**FLOOD DETENTION DAMS - 2023
INTERMEDIATE DAM SAFETY REVIEW**

Prepared for:
Hastings District Council

Prepared by:
Stantec

Flood Detention Dams - 2023 Intermediate Dam Safety Review

Table 4-8: Summary of Here Here Dam Site Inspection

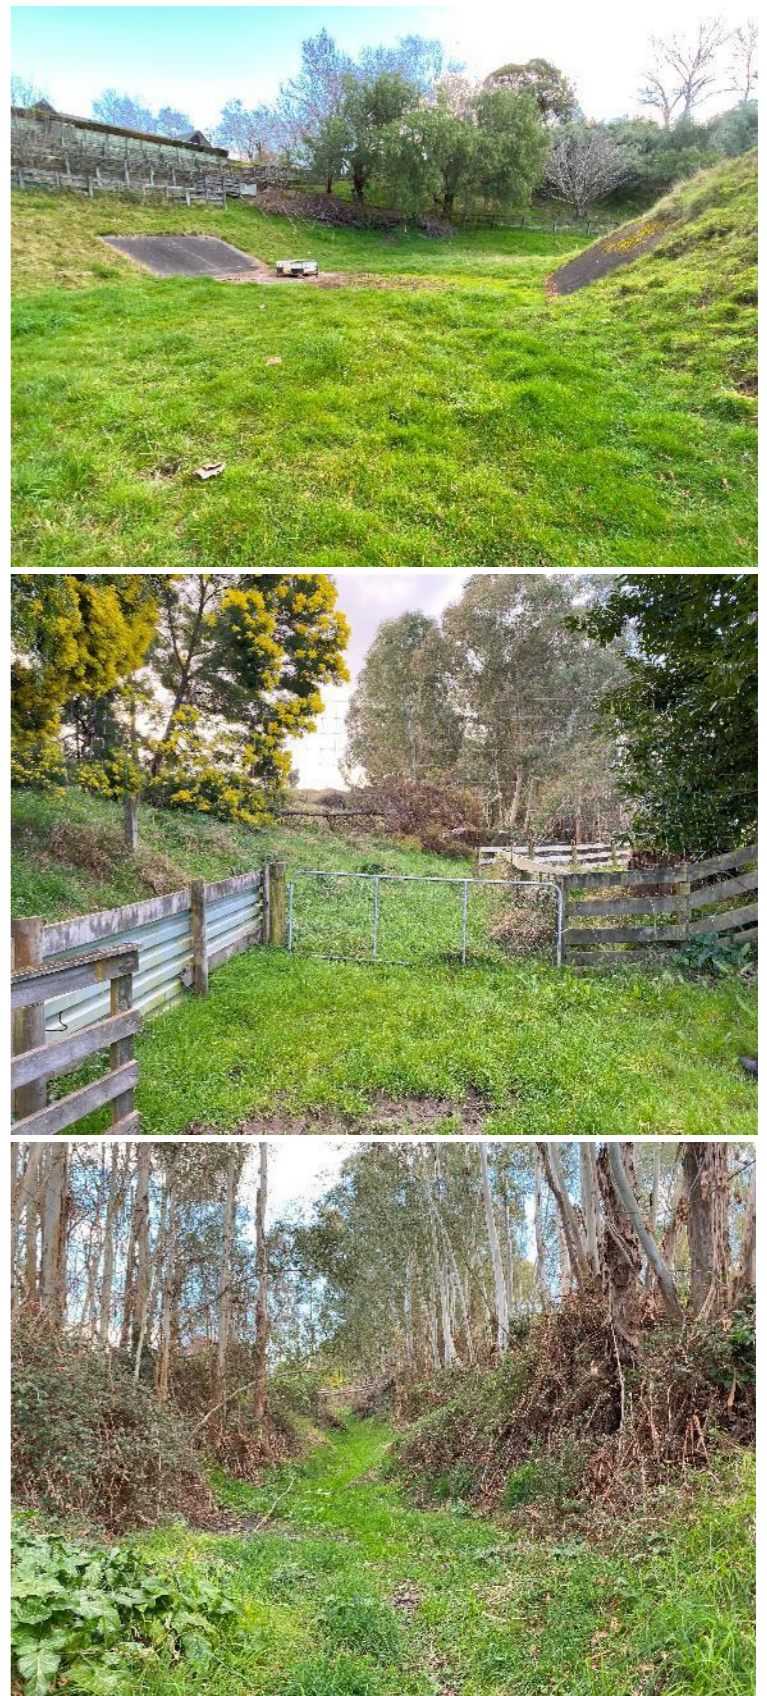
| Dam or Appurtenant Structure | Key Site Inspection Observations | Dam safety issue | Photograph |
|-------------------------------|---|---|--|
| <p>Embankment</p> | <p>The upstream face was in satisfactory condition with stable slopes. There were no obvious signs of movement or settlement across the dam crest.</p> <p>The downstream face was similar to the upstream face and crest. The trees on the downstream left and right abutments were close to encroaching on the embankment which could lead to penetrating roots. These trees should be removed.</p> | <p>Remove the trees from the downstream left and right abutment areas (previous DSI).</p> |  |

| Dam or Appurtenant Structure | Key Site Inspection Observations | Dam safety issue | Photograph |
|---|---|---|---|
| <p>Outlet Structure and Downstream Channel</p> | <p>The downstream channel was scoured in a few places but generally in satisfactory condition. There was some fencing and a small bridge that had a build-up of debris and should be removed to allow flow downstream.</p> <p>The stilling basin was generally in satisfactory condition but one of the dissipators had been sheared off and there was some build-up of sediment on the right side of the stilling basin. The vegetation seen in the previous inspection has been washed away. The reverse-flap gate (corrugated iron sheet) was in poor condition but still serves its purpose (presumably for stock exclusion).</p> <p>There were some small vertical holes behind the left wall of the outlet structure that cannot be explained. They were too uniform for animals, and it was difficult to determine the depth. Downstream of the outlet structure there was some scour of the stream banks.</p> | <p>Repair the dissipation block that had been damaged.</p> |  |

Figure 6-4: Mangarau Dam Water Levels and Rainfall (July 2022 – August 2023)

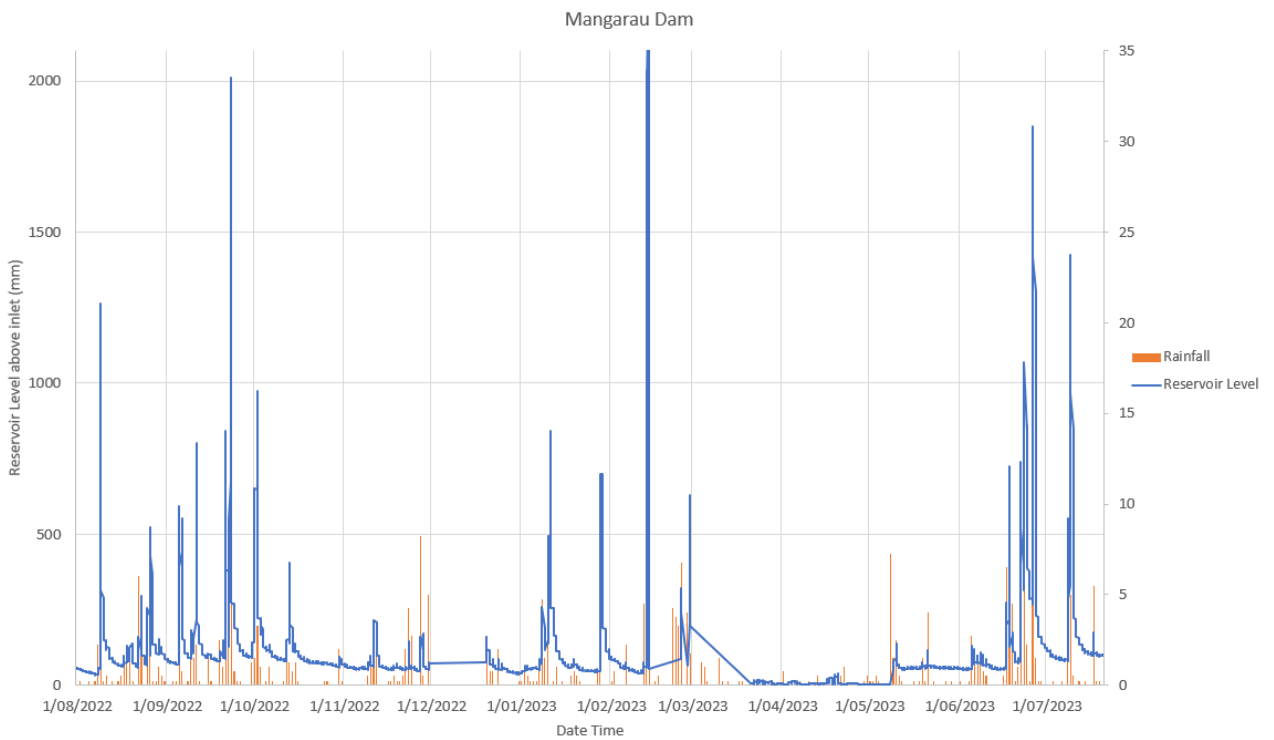
This system seems to be performing well but has not been calibrated in a long time. If possible, increase the frequency of readings to say 15 minutes for more accurate data in floods. The system should also have alarms where notification is given for set rainfall and reservoir levels.
